SERVICE BULLETIN

Service Bulletin No. / Date: SB TMG 691-1001 P1, Initial Issue / November 05, 2014

Subject: Turbocharger Clamp Replacement

Type affected: All DA40 with TAE 125-02-114

Figure 1

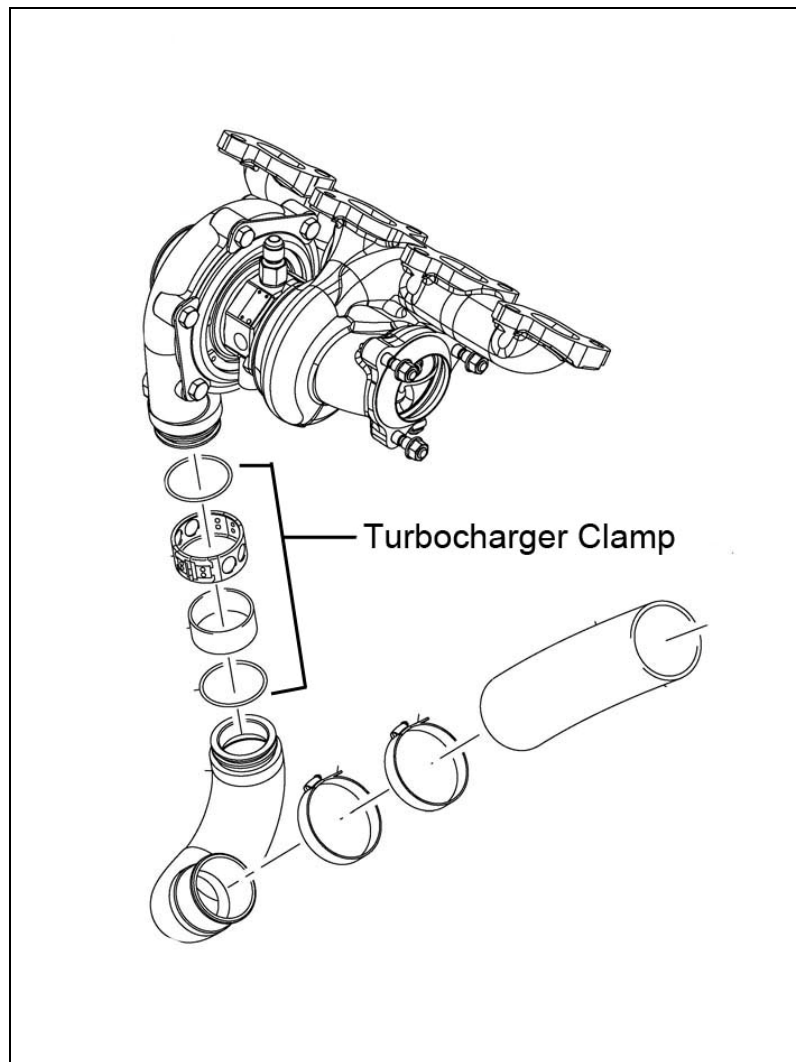
1. Remove the turbocharger clamp:

- Make sure that the engine is cold before starting work at the engine.
- Remove the turbocharger clamp including the inner ring and the O-rings.
- **CAUTION:** When opening of the turbocharger system, pay special attention to prevent contamination.

Figure 2

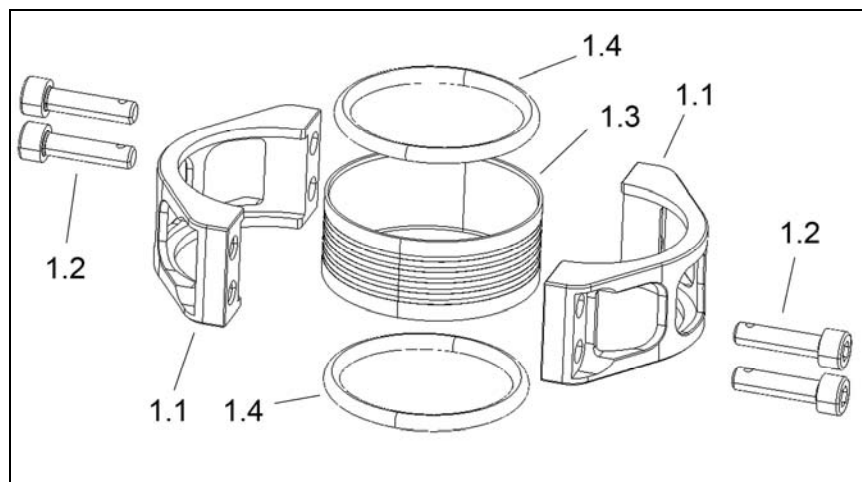
- Attach one O-ring (item 1.4) to the notch at the flange of the turbocharger.
- Attach the other O-ring (item 1.4) to the notch at the turbo pipe.
- ◆ Note: Use lubricant for installation of the O-rings and the coupling. Check correct fit.
- Connect the turbo pipe to the turbocharger and secure with the coupling (item 1.3) and the two half shells (item 1.1) using four screws (item 1.2). See Figure 2.

Tightening Torque: 8Nm

- Check if the clamp can be moved easily.
- ◆ Note: Tension at the clamp or misalignment of piping can lead to deformation or damage.
- Secure the screws with safety wire. See Figure 3.
